Essential Fitting Information

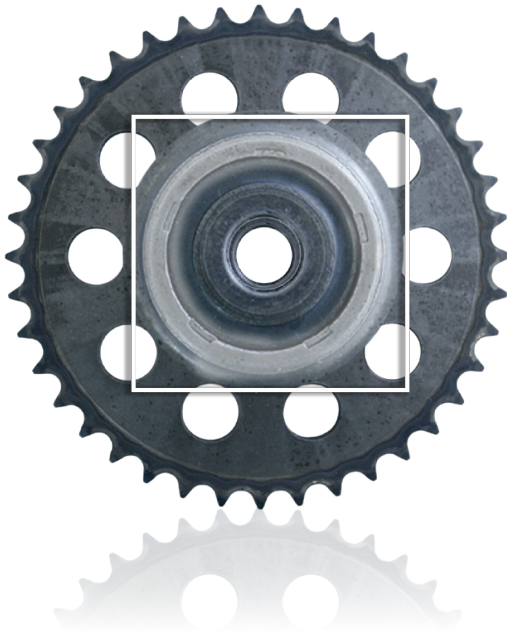
The original GM timing gears for this engine up to engine number 19DN0327 were made from sintered material and included a built in spacer/washer.

Later engines used pressed steel gears which did not require the spacer/washer. GM have stopped production of the early gears and now only offer the later pressed steel gears which can be found in this FAI kit.

Old Sintered Design

New Pressed Steel Design

Important: Sintered and pressed steel gears must NOT be mixed.

When replacing the old design gear for the new pressed steel design. You will need to assemble the new components as shown in the diagram.

NB: Be sure to fit the spacer/washer with the flat surface forward (touching the pickup trigger plate).
